### 5.3. REQUEST FOR PERMISSIBLE CHANGE TO PLANNING APPROVAL 24 MUDLO STREET, PORT DOUGLAS

**PROPOSAL** Request for Permissible Change

**LOCATION OF SITE** 24 Mudlo Street, PORT DOUGLAS

# MUDLO STREET VILLAS

**SITE PLAN - PROPOSED**  
1:200 @ A3

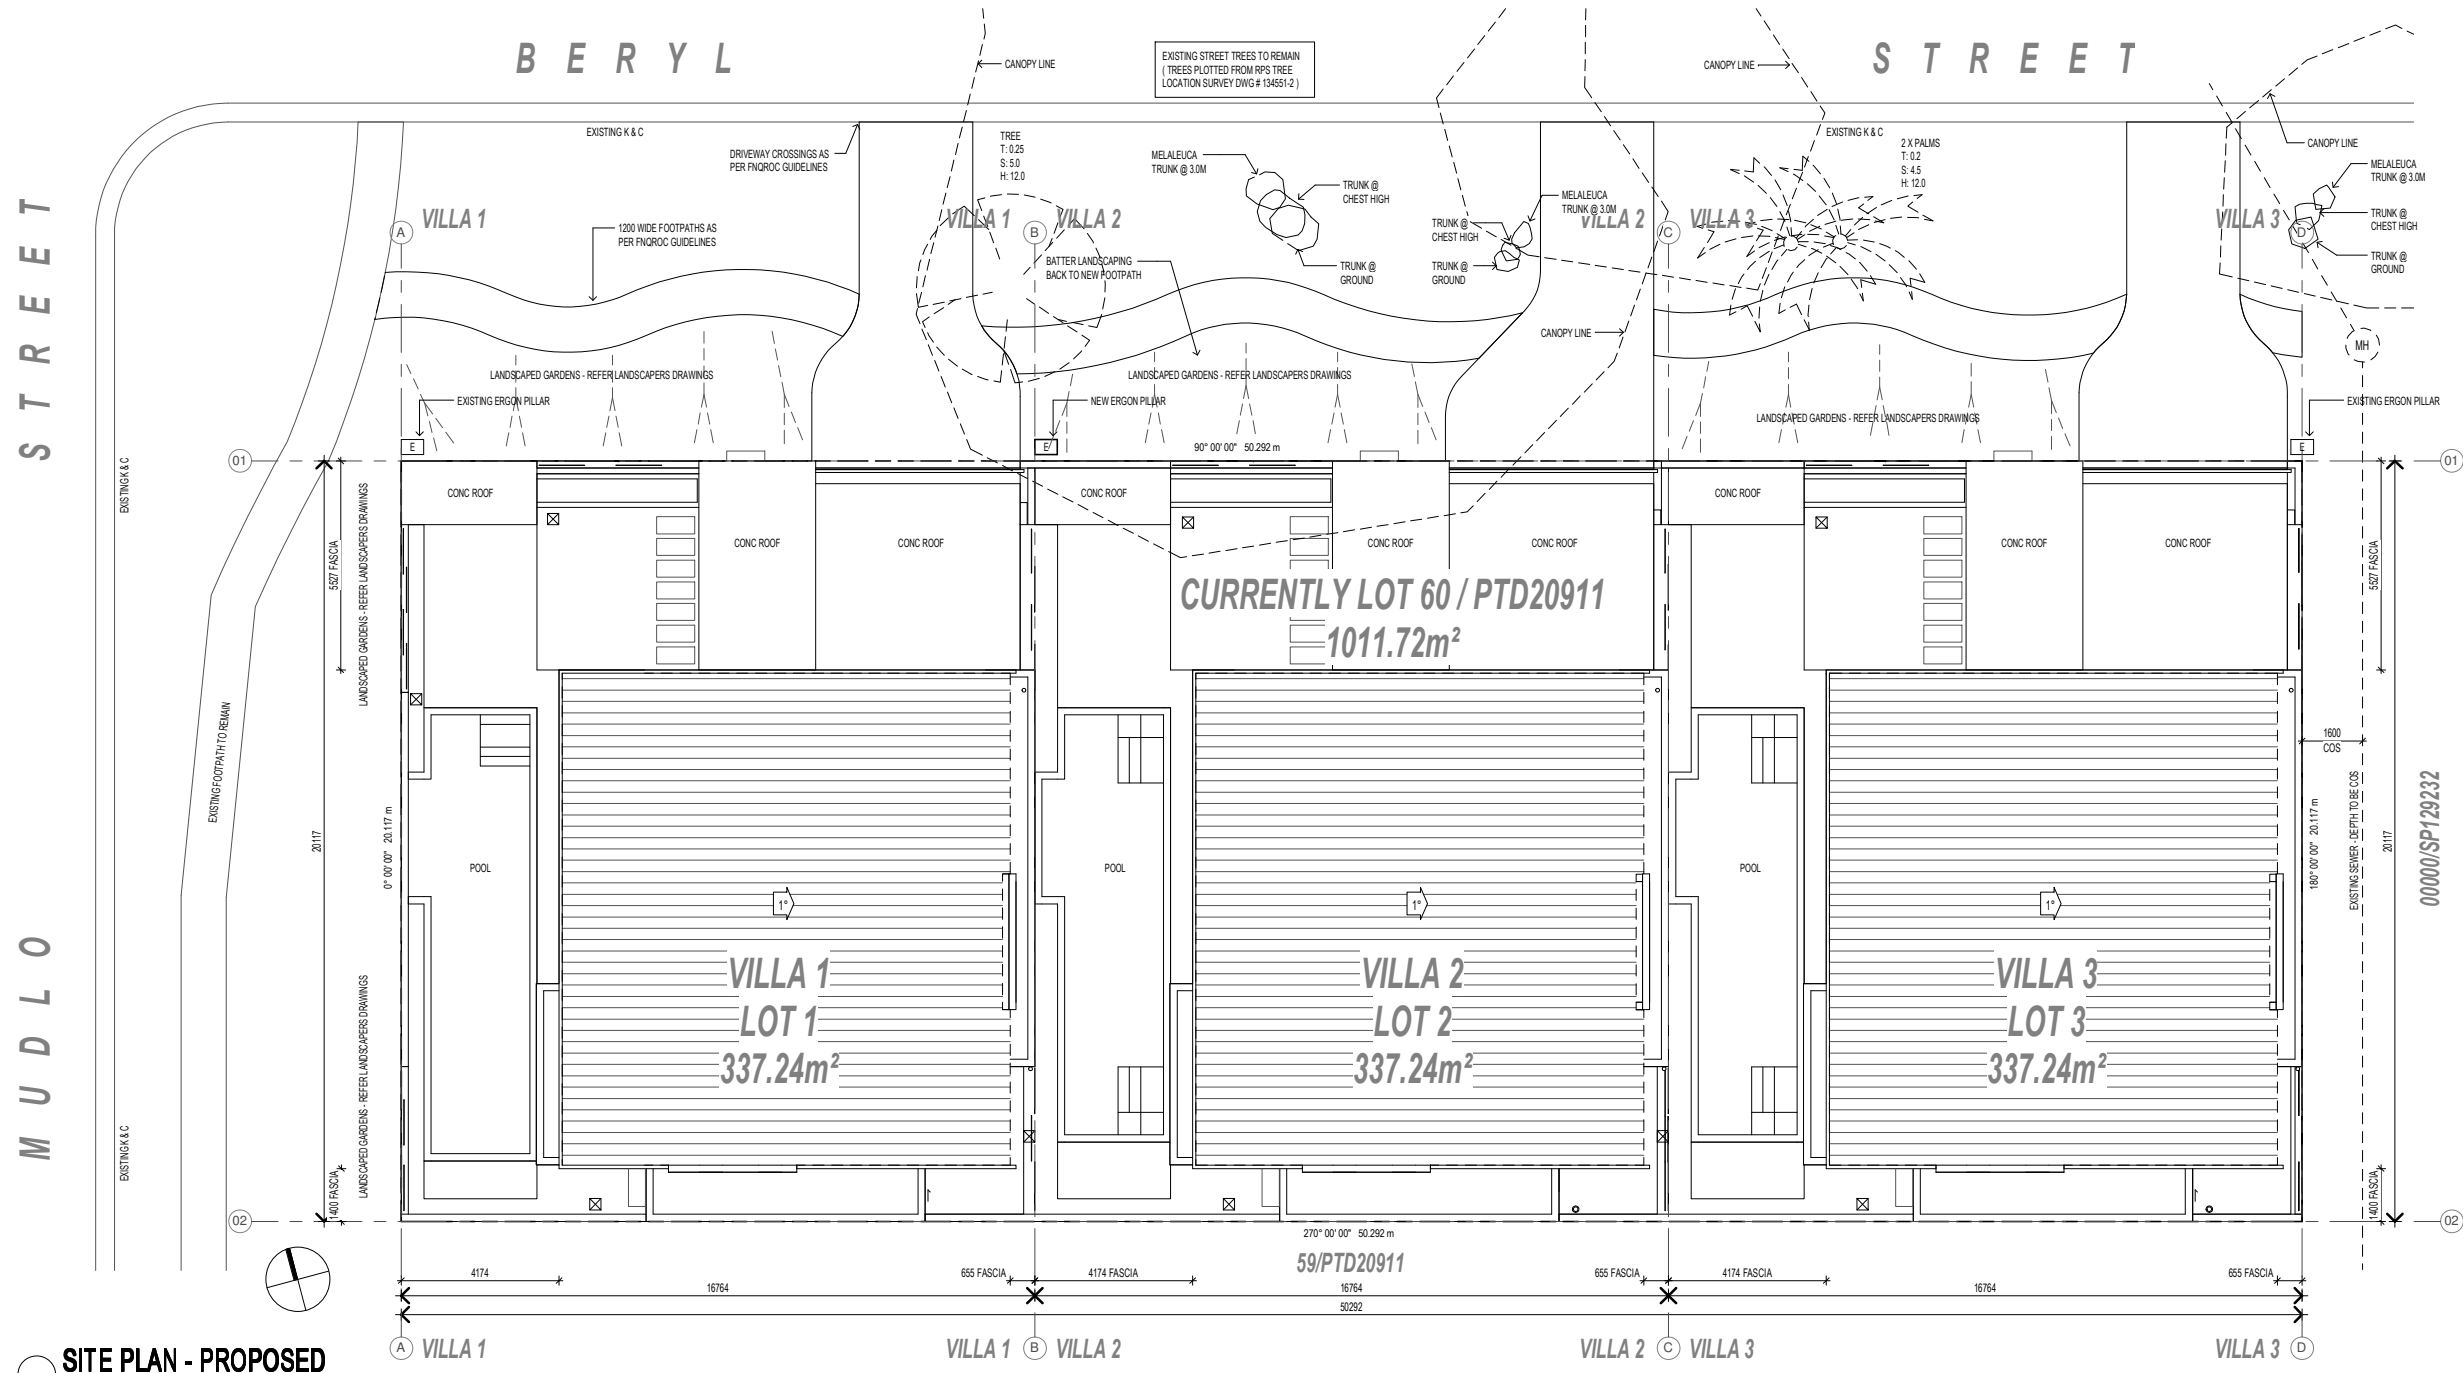
The revised site plan is included as Attachment 1. The proposed changes to the approved development include a concrete roof structure over the designated parking area of each unit of housing and include a concrete roofed gate house at the centre of each dwelling unit. A rendered view of the proposed changes can be seen below in figure 2.

- Addition of a concrete roofed car port ;
- Addition of a concrete roofed gate house.

**Building Setbacks-** The proposed gatehouse of each unit is to be sited up to the front boundary for a length of three (3) metres. The proposed car port of each unit is to be sited up to 600mm from the front boundary. This significantly encroaches on the acceptable solution of a 6 metre street frontage setback, however, given the high scale and pattern of three storey development surrounding the proposal; it is considered that the built form of the development does not result in contributing to a bulky and obtrusive streetscape. Further, the significant street trees at the sites frontage deliver a screened and softened effect on the proposed developments appearance.

- 25. This approval does not include the configuration of the footpath or on street landscaping works as detailed on *Site Plan- Proposed* dated 29 June 2017, prepared by Nathan Verri Masters of Design and Building.**

**Tree Location Survey**  
 Adjacent Lot60 on PTD20911  
 Beryl and Mudlo Streets  
 Port Douglas  
 Queensland

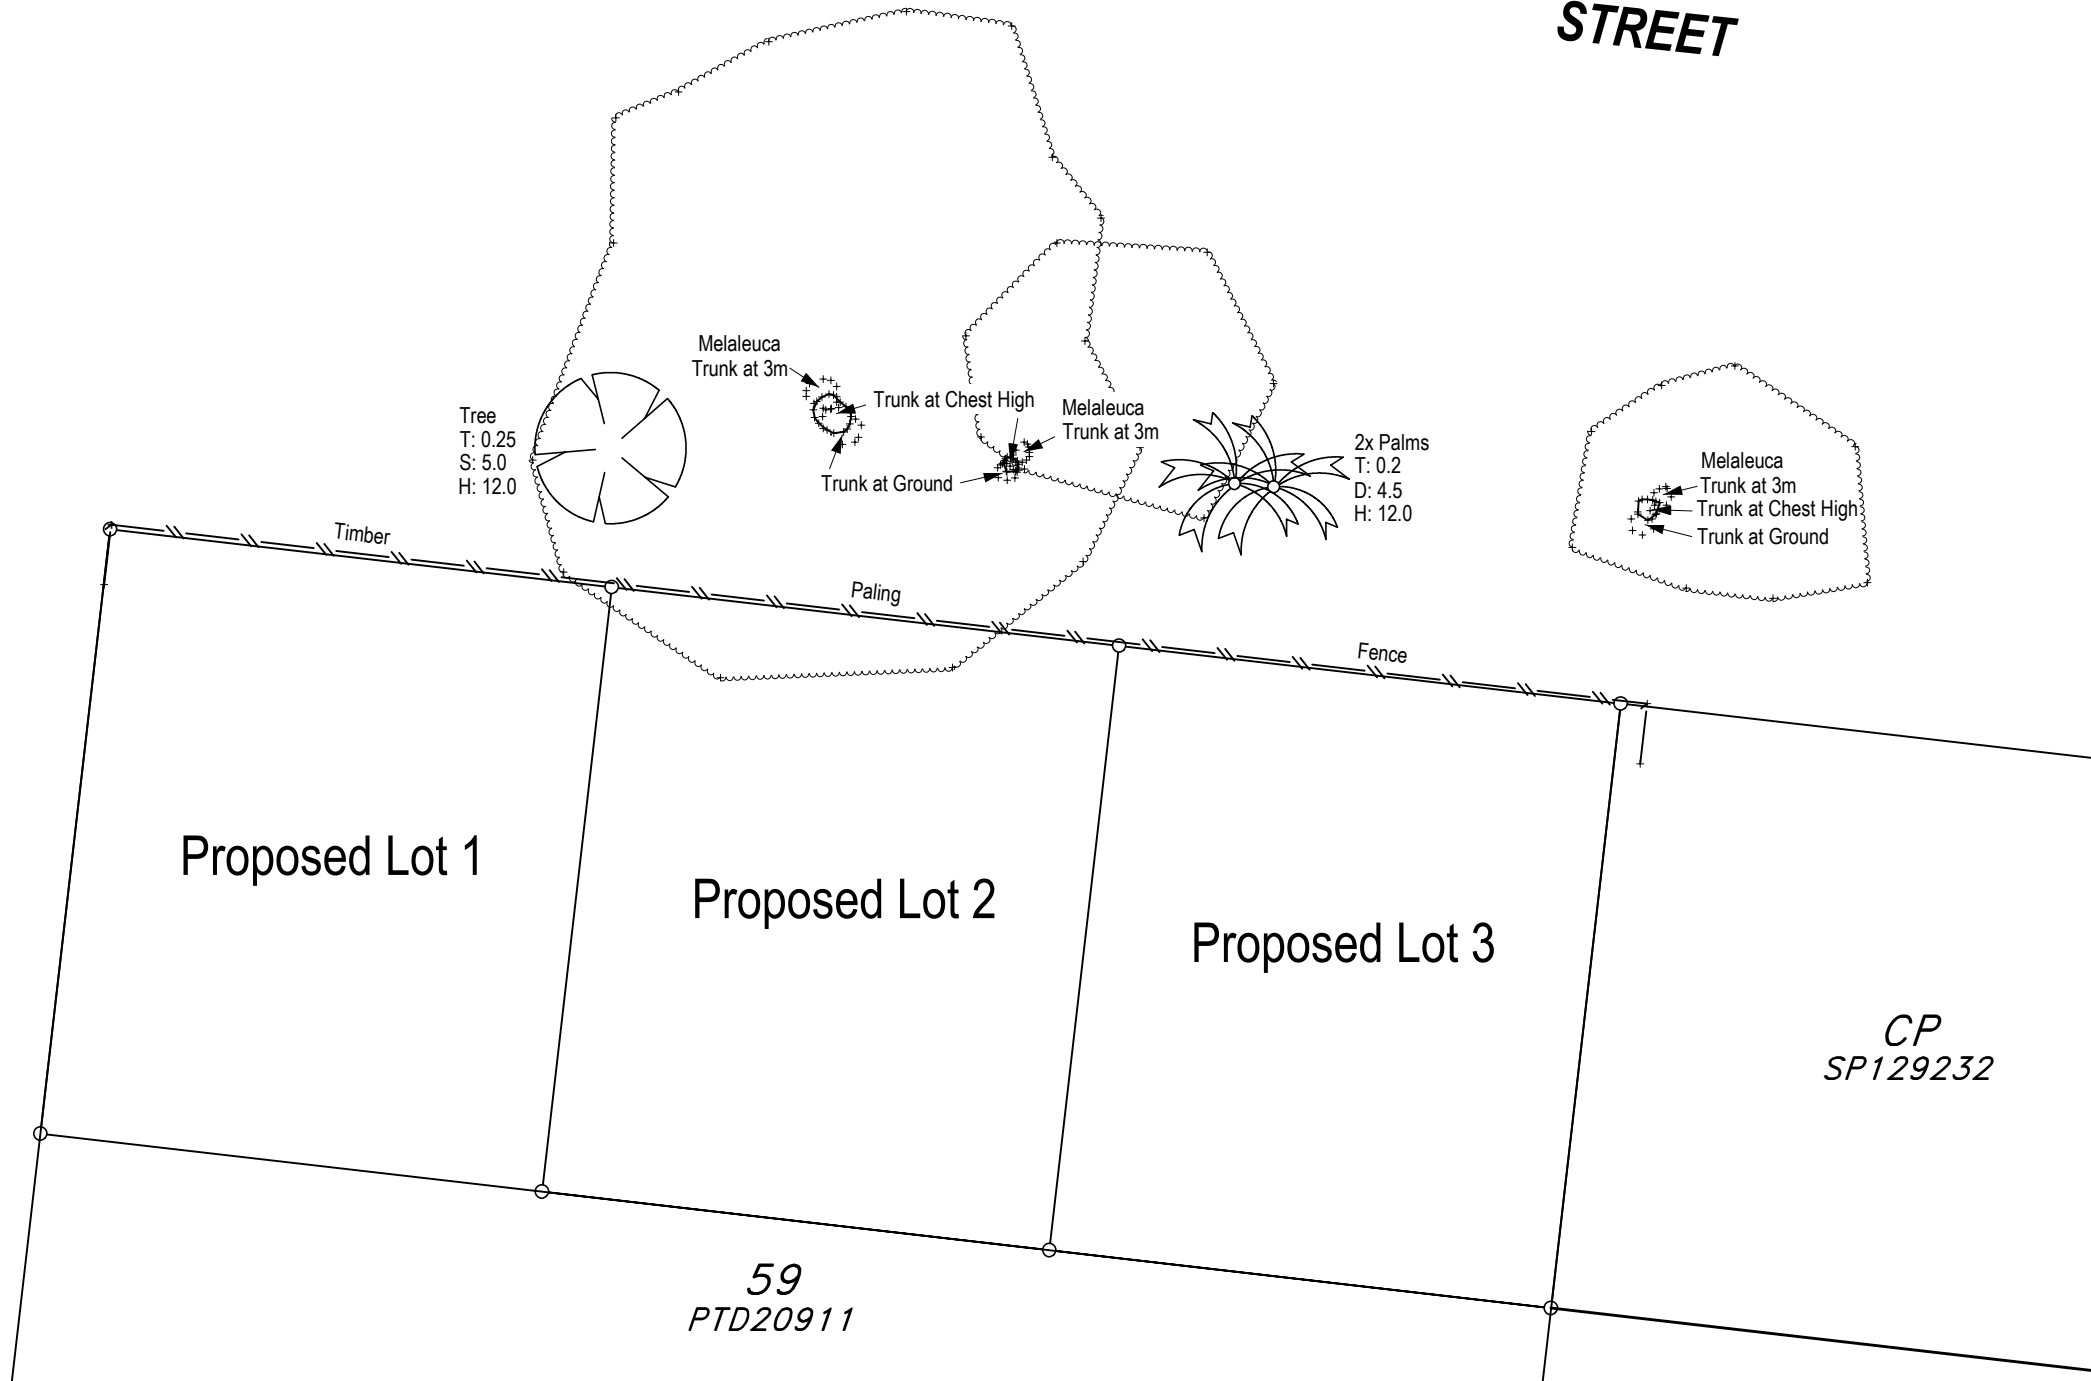
8. **Undertake a survey identifying the street trees at the Beryl Street verge. Indicate the diameter, canopy cover and root sprawl of the significant street trees. Detail how the proposed access to each dwelling relates to each of the significant street trees and how this may effect a consequent amendment to design.**

**An investigation to develop the most appropriate driveway access and to determine the least impact on the significant street trees within the road reserve of Beryl Street must be undertaken by an appropriately qualified arborist. Regard must be given to Australian Standard 4970-2009/Amdt 1-2010 (Protection of Trees on Development Sites). This investigation will be paramount in determining driveway access and footpath development. A plan detailing the above requirements must be submitted to Council for endorsement by the Chief Executive Officer prior to the issue of the development permit for building work.**
